APPLICATION FOR MODIFICATION ASSESSMENT REPORT

Application Number:	Mod2024/0245		
Responsible Officer:	Nick England		
Land to be developed (Address):	Lot B DP 419338, 11 B Hill Street WARRIEWOOD NSW 2102		
Proposed Development:	Modification of Development Consent DA2023/0206 granted for Construction of a dwelling house		
Zoning:	C4 Environmental Living		
Development Permissible:	Yes		
Existing Use Rights:	No		
Consent Authority:	Northern Beaches Council		
Land and Environment Court Action:	1: No		
Applicant:	Worthington Homes		
Application Lodged:	21/05/2024		
Integrated Development:	No		
Designated Development:	No		
State Reporting Category:	Refer to Development Application		
Notified:	28/05/2024 to 11/06/2024		
Advertised:	Not Advertised		
Submissions Received:	1		
Clause 4.6 Variation:	Nil

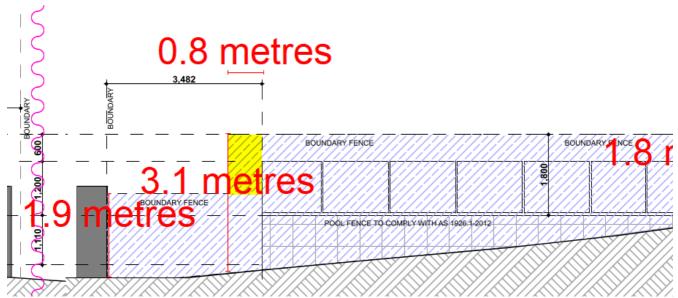
The proposed boundary fence on the rear southern boundary will reach a height of 3.1m for a short distance of 0.8m, above the 1.8m control. This is result of the existing ground level transitioning rapidly

from the proposed pool (which is not dissimilar from the existing pool) to the remainder of the private open space. An excerpt from the plans, shows this non-compliance (in yellow) when viewed from the south elevation:

In summary, despite the variation with the numerical control, the proposal can meet the Outcomes of the control and full compliance is not considered necessary under the circumstances.
